1931 2ND AVENUE

DESIGN RECOMMENDATION MEETING #2

DPD PROJECT #: 3007606

SEPTEMBER 09, 2008

OPTION 1: : PEDESTRIAN VIEW FROM EAST

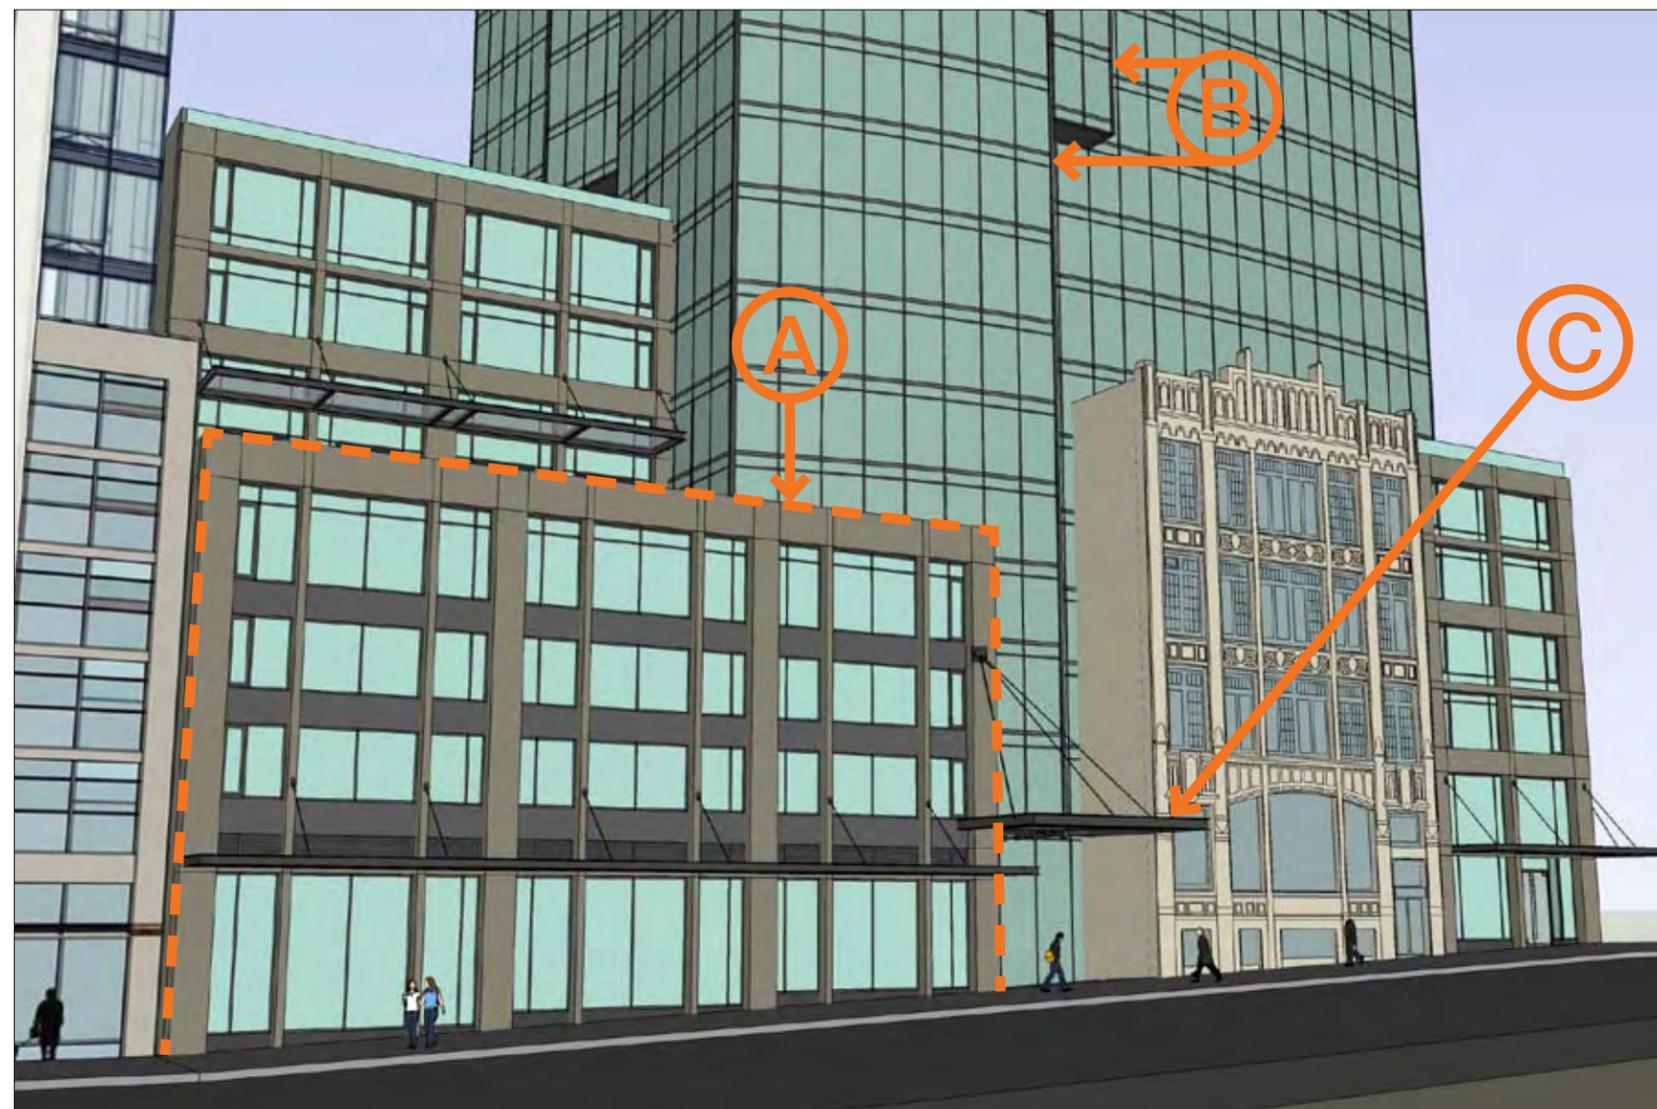
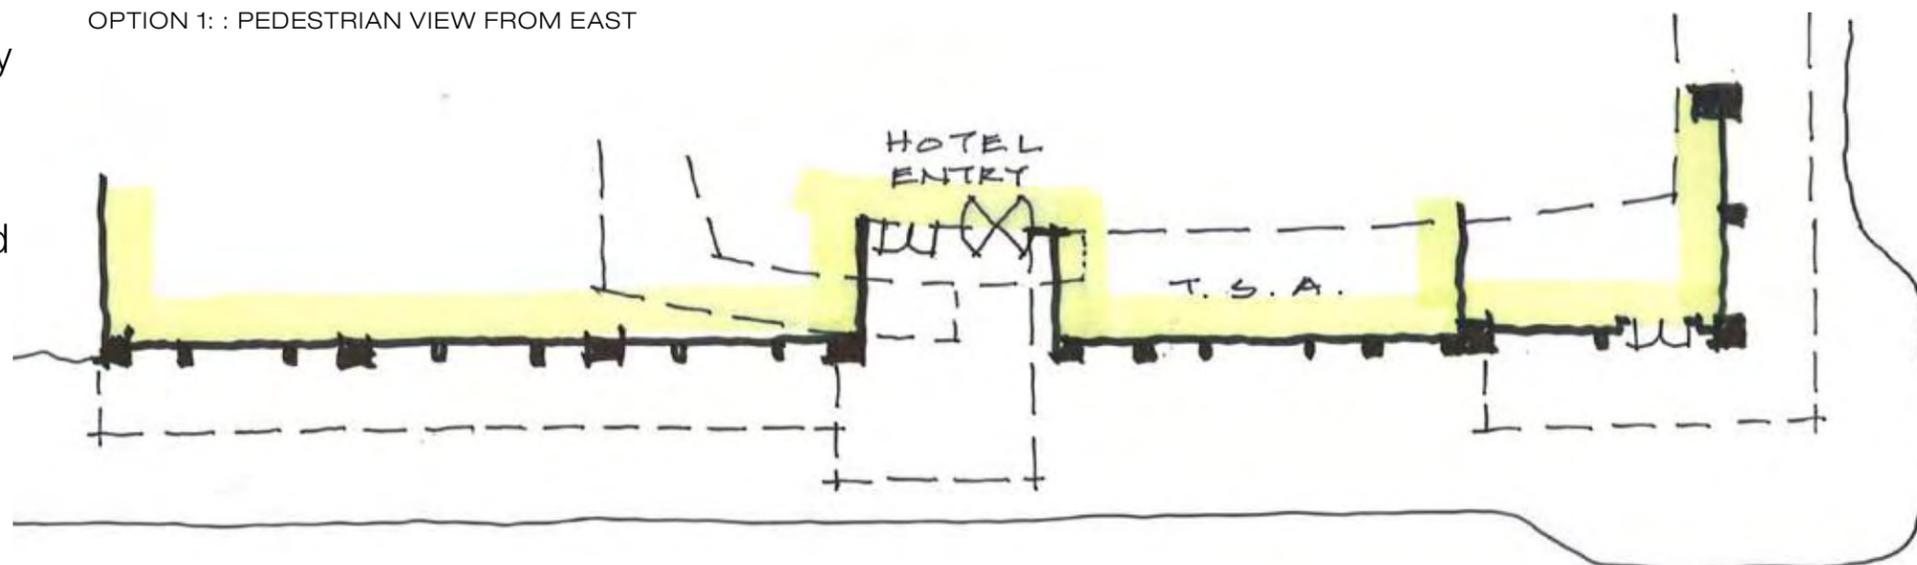
A • The committee largely preferred the base of option 1, maintaining the 3 bay parking structure element. This was seen to relate somewhat to the tri-partite base elements on the TSA facade.

- Some interest was shown for the 2-1/2 bay base in option #3 but that interest was deferred to the architects to choose what was best for the building.

B • The committee largely preferred the tower of option 3, which moved 2 tower massing elements 5 ft south.

- The committee would like further exploration of any possible ways to physically or otherwise expose the south wall of the TSA more. Options include moving the glass plane back at the "hyphen" or exposing the wall through the clear glass entry and upper levels.

C • Tensile canopy support from side structure too dynamic.
